GRANDVIEW FILING 2 WATER AND WASTEWATER CONSTRUCTION DOCUMENTS

LANDSCAPE PLAN
SEPTEMBER 2024

D.R. HORTON - GRANDVIEW RESERVE
 SANITARY SEWER LIFT STATION
 DESIGN & PERMITTING SERVICES
 EL PASO COUNTY
 PEYTON, CO

Comment response for LANDSCAPE PLANS

EROSION AND GRADING CONTROL PLANS
 COVER SHEET

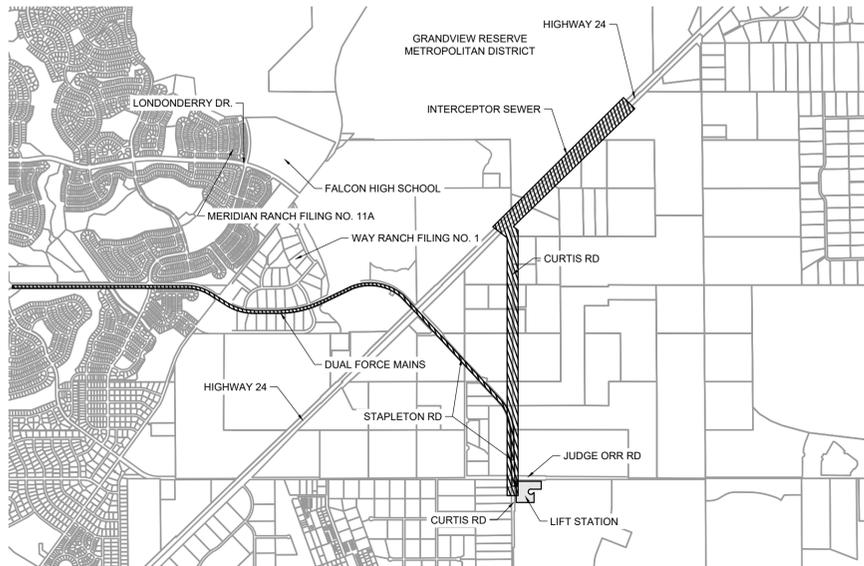
unresolved :
please title as
substitute landscape
plan

Page No	Comments	Response
1	This is for the substitute landscape plan not grading please revise pages 1-2	Cover sheet and Legend sheet (Page 1 and 2) updated
